ADDENDUM NUMBER ONE
CHATTANOOGA PUBLIC LIBRARY – CHILLER AND BOILER IMPROVEMENTS
CONTRACT NO. L-18-001
JANUARY 25, 2019
CITY OF CHATTANOOGA, TENNESSEE

The following changes shall be made to the Request for Bids:

Public Library Chiller and Boiler Improvements

Title:
**Fourth Floor Plans
 (Partial)**

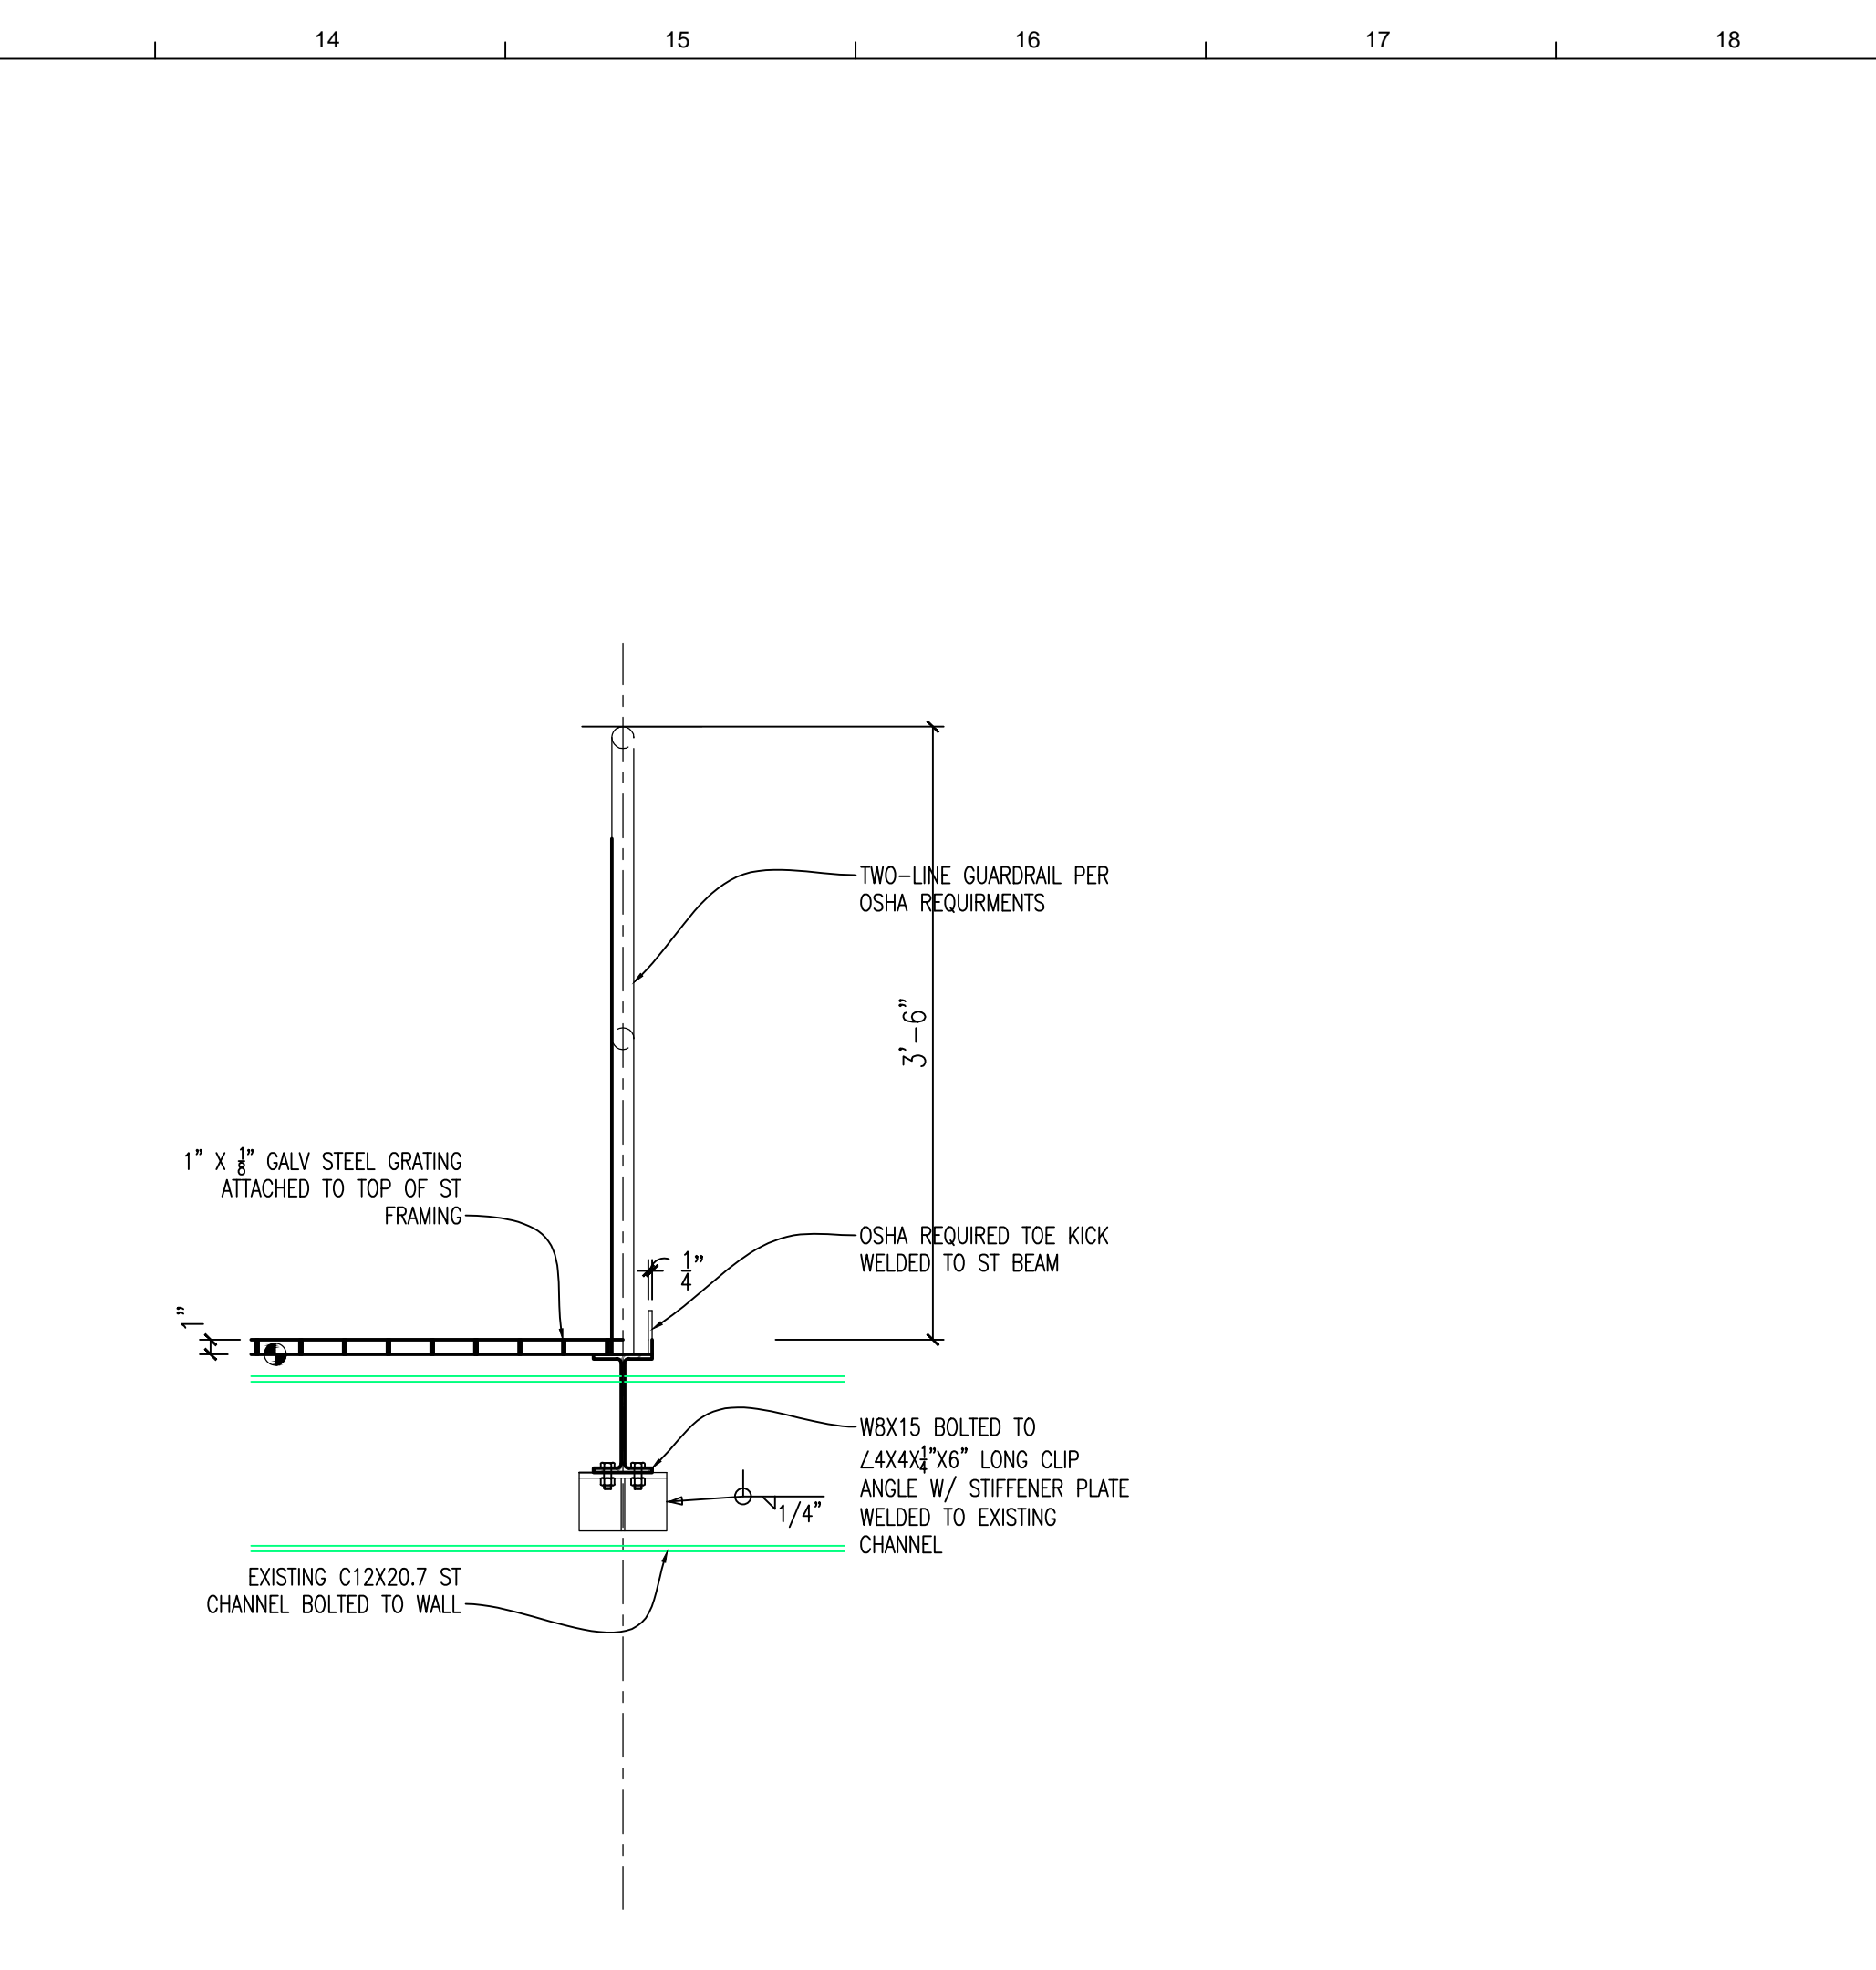
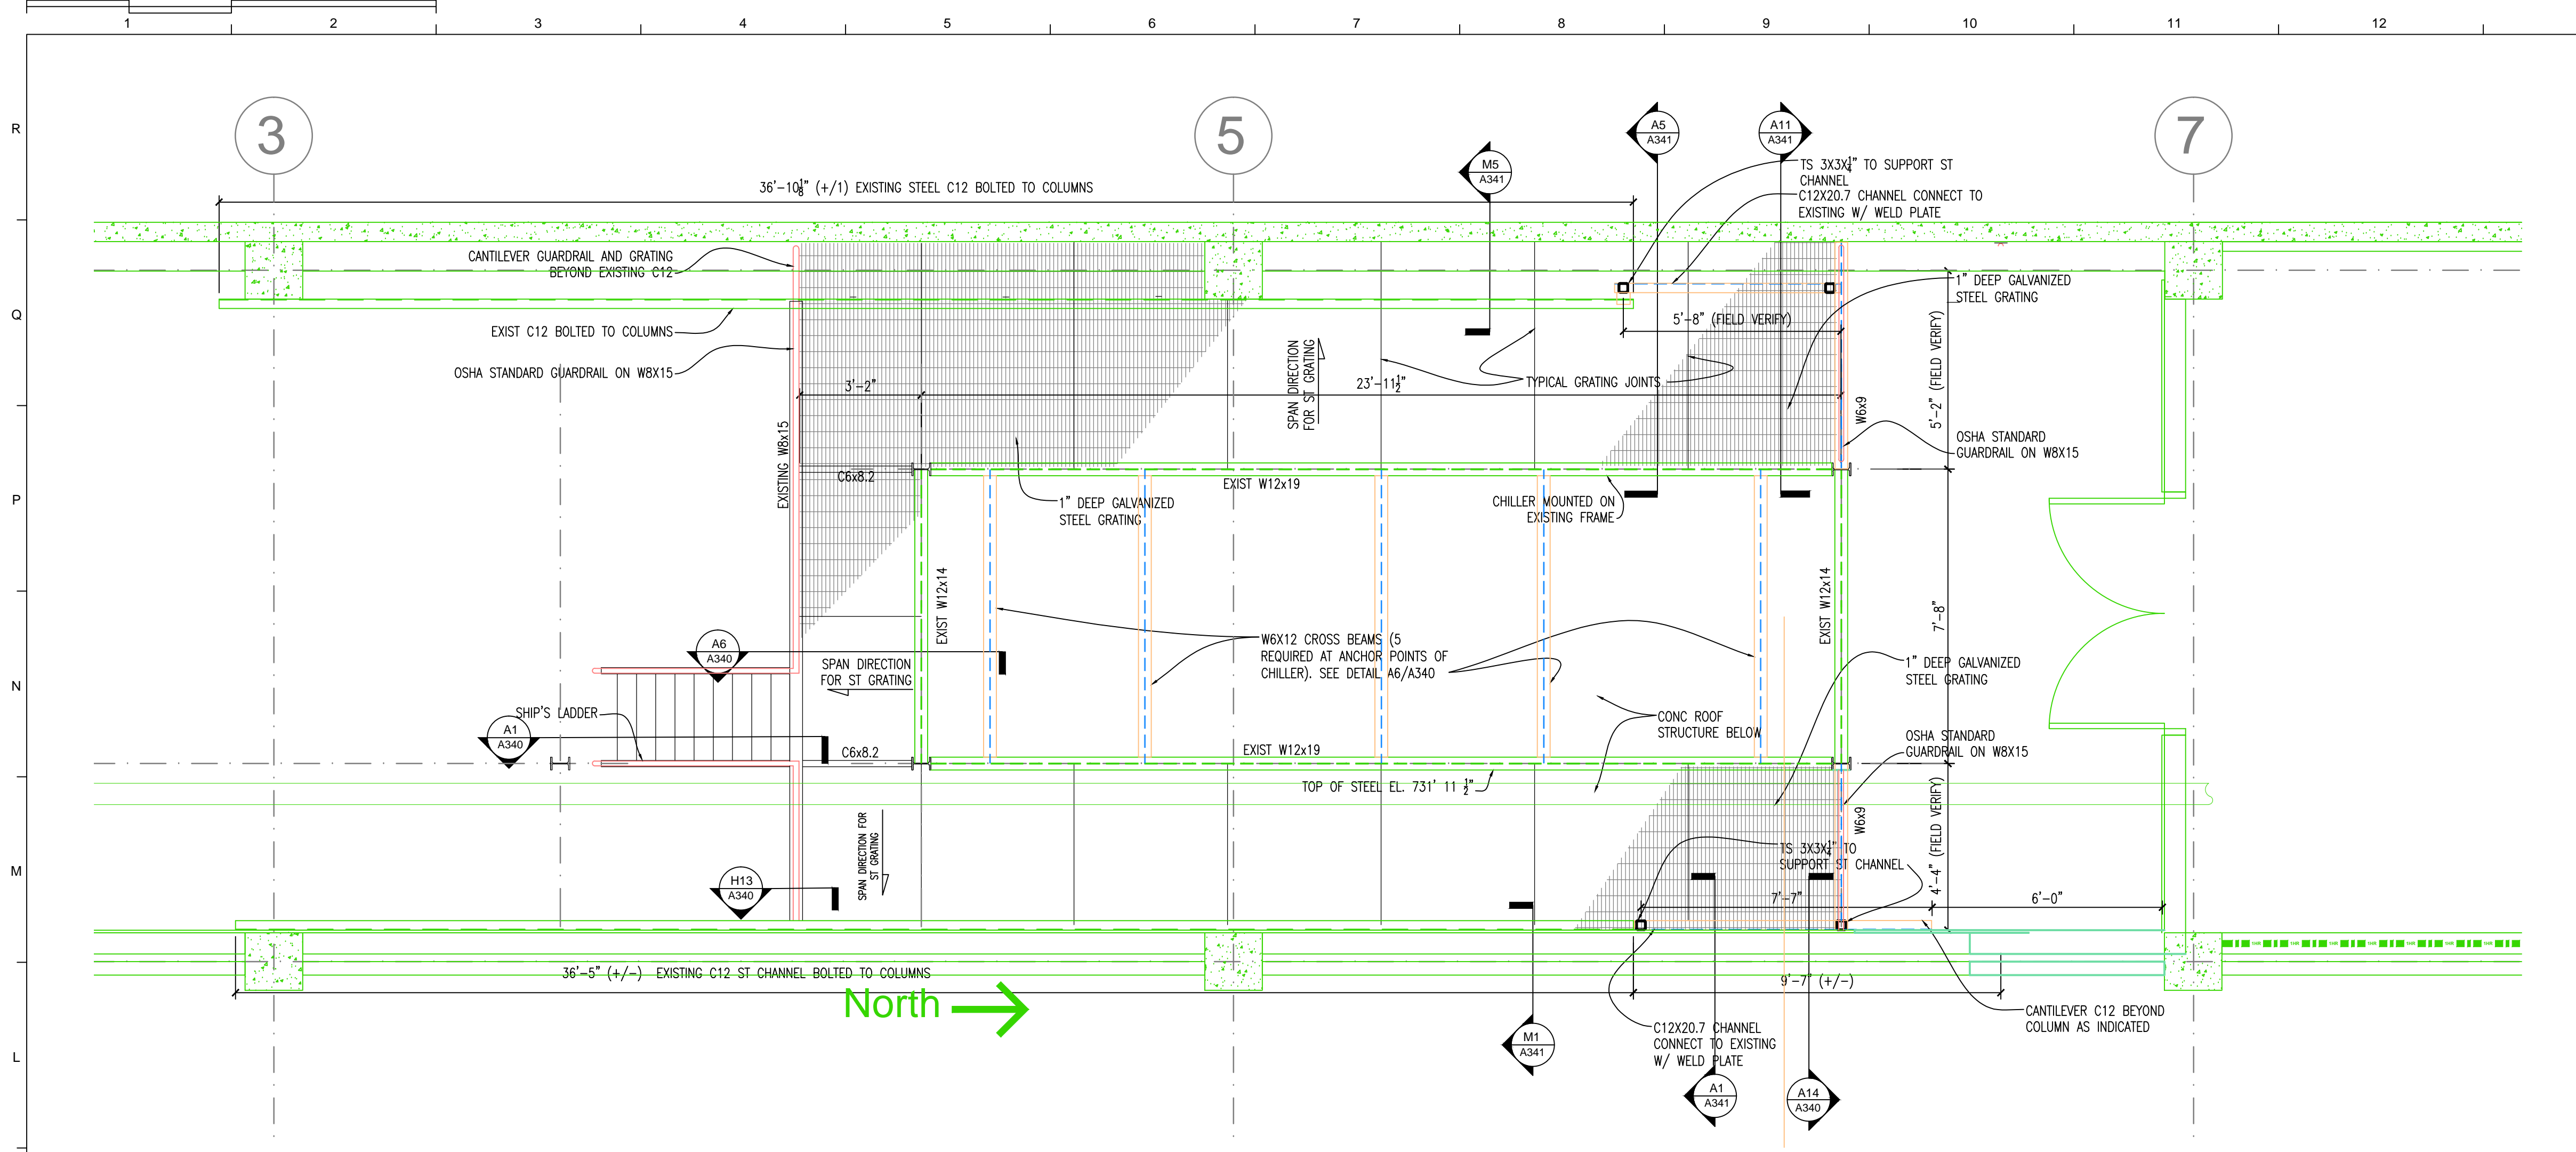
- a. Sheet A-104 Fourth Floor Plans (Partial) is re-issued as part of this addendum and describes revisions to the housekeeping pads.

Title:
**Fourth Floor HVAC
Roof Well Plans and
Details**

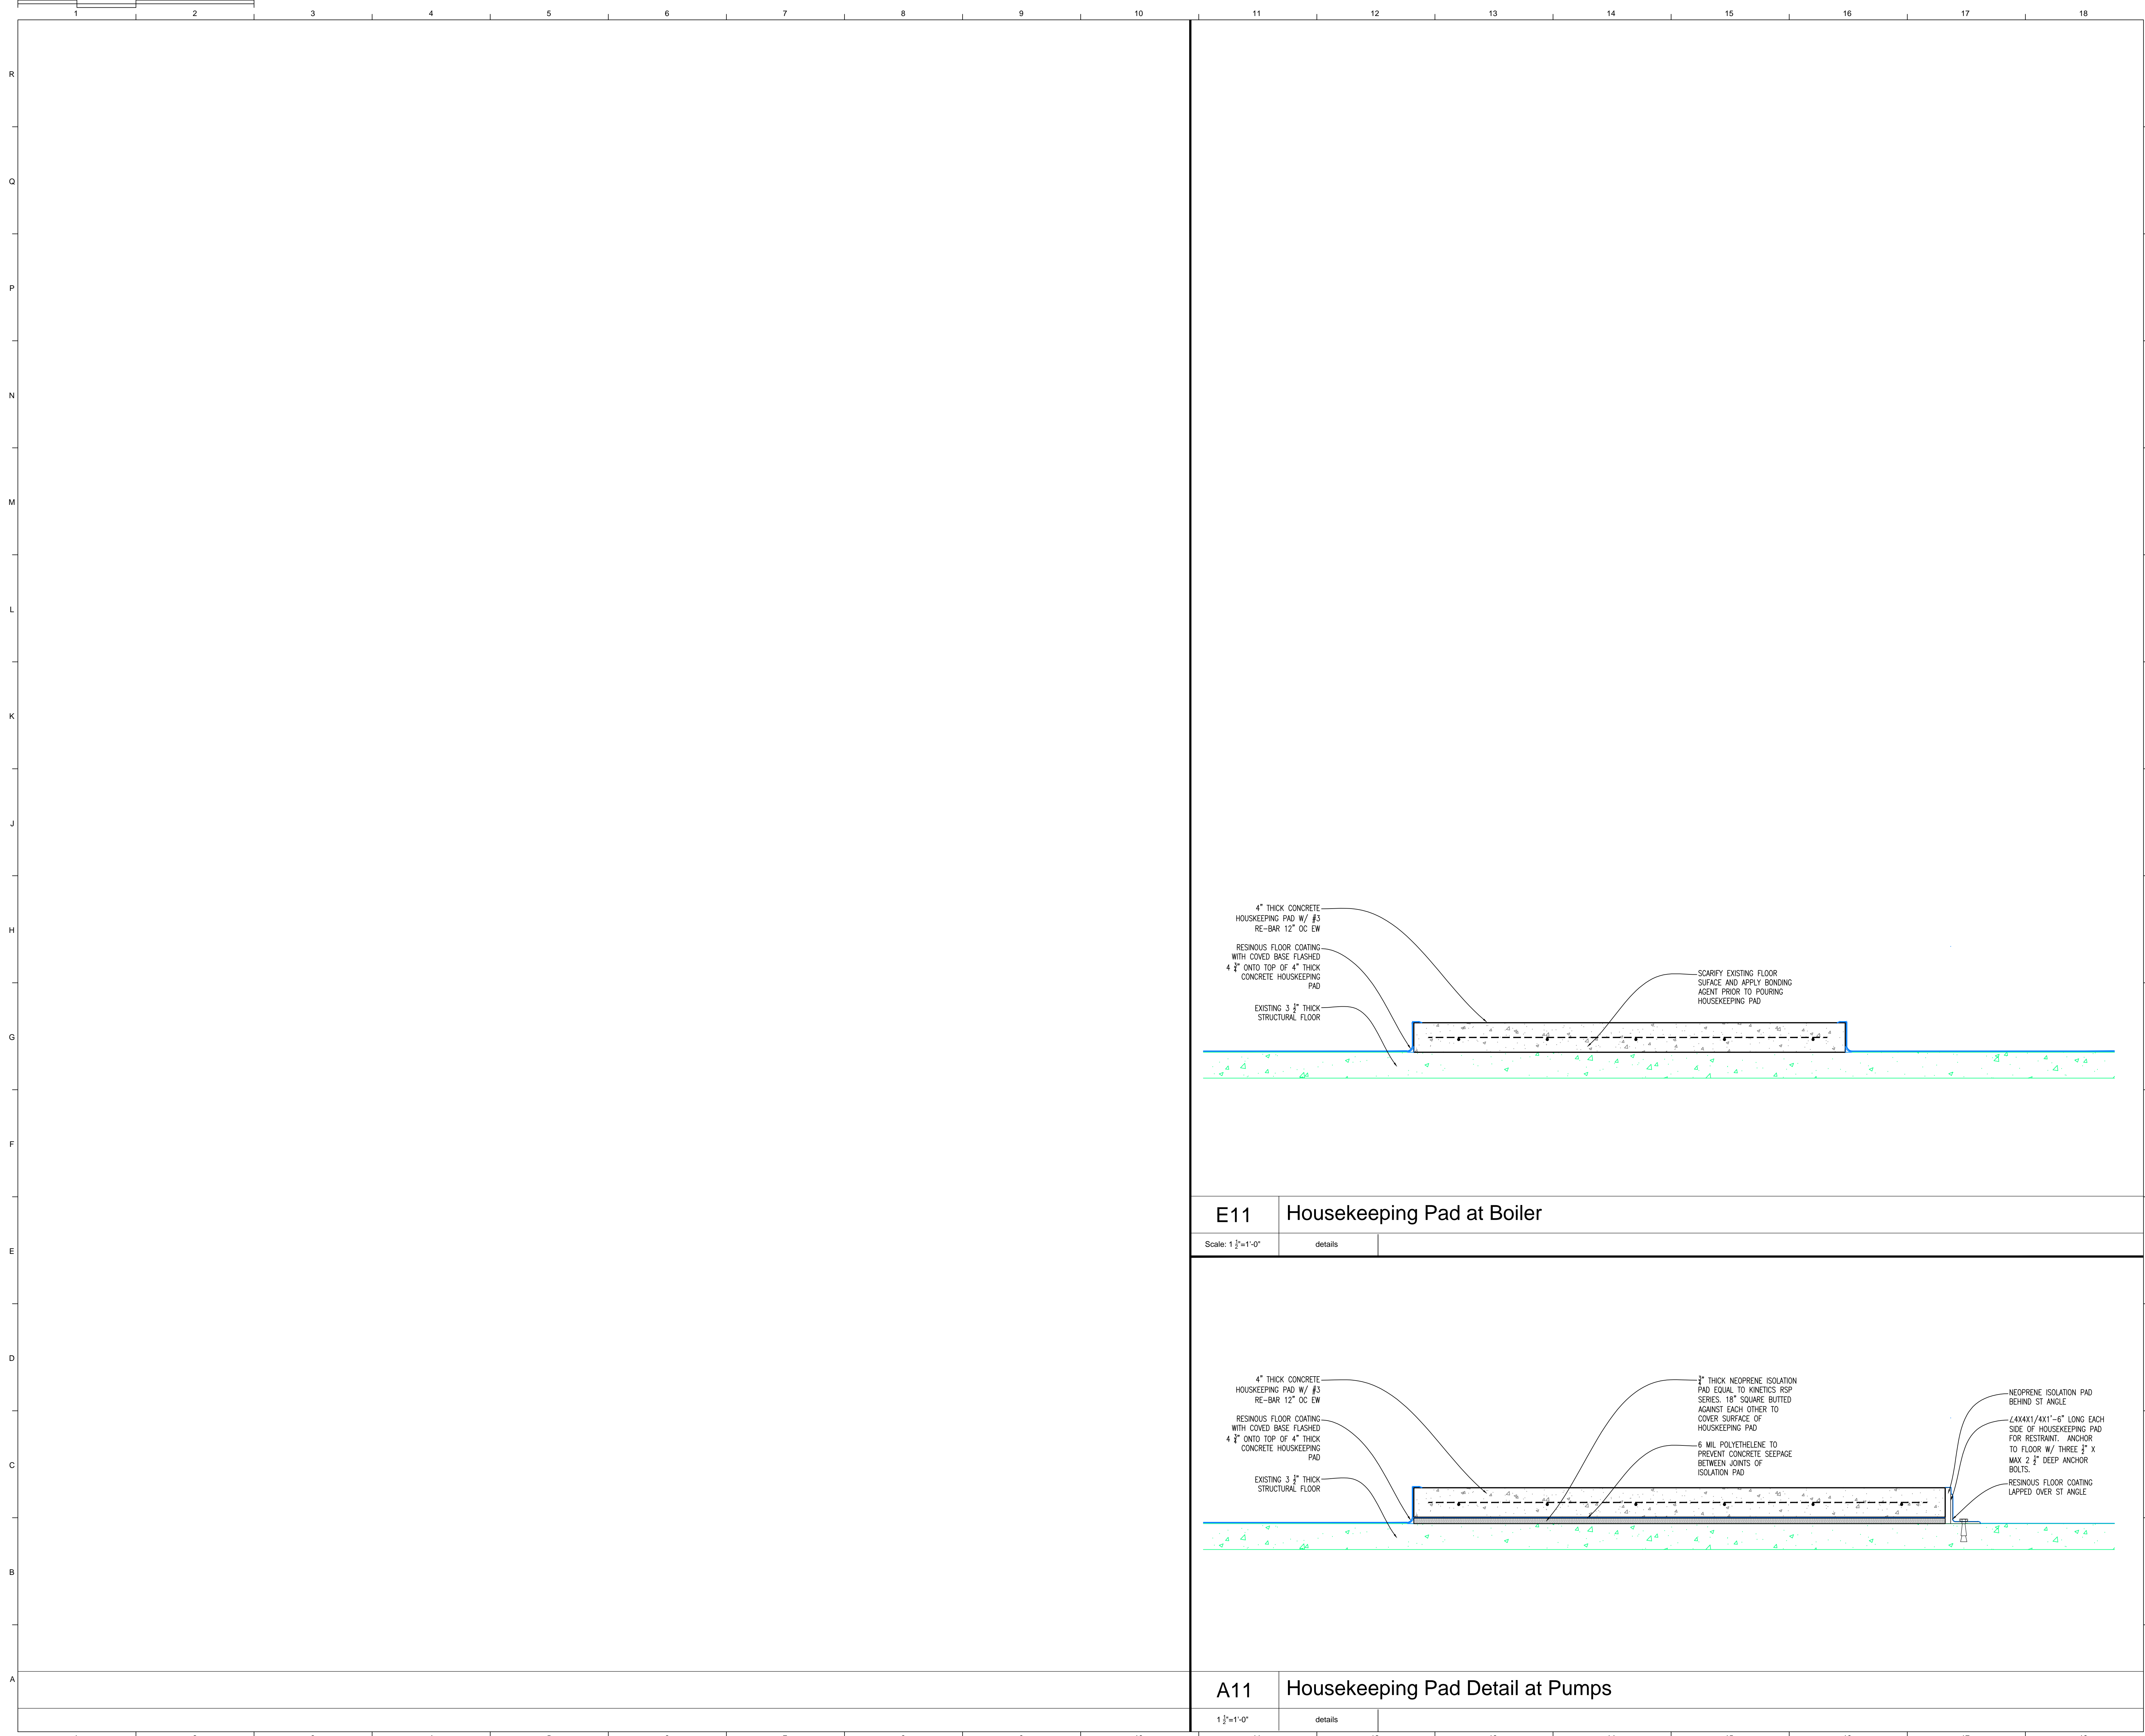
- b. Sheet A-340 Fourth Floor HVAC Roof Well Plan and Details is re-issued as part of this addendum and indicates the deletion of a housekeeping pad detail.
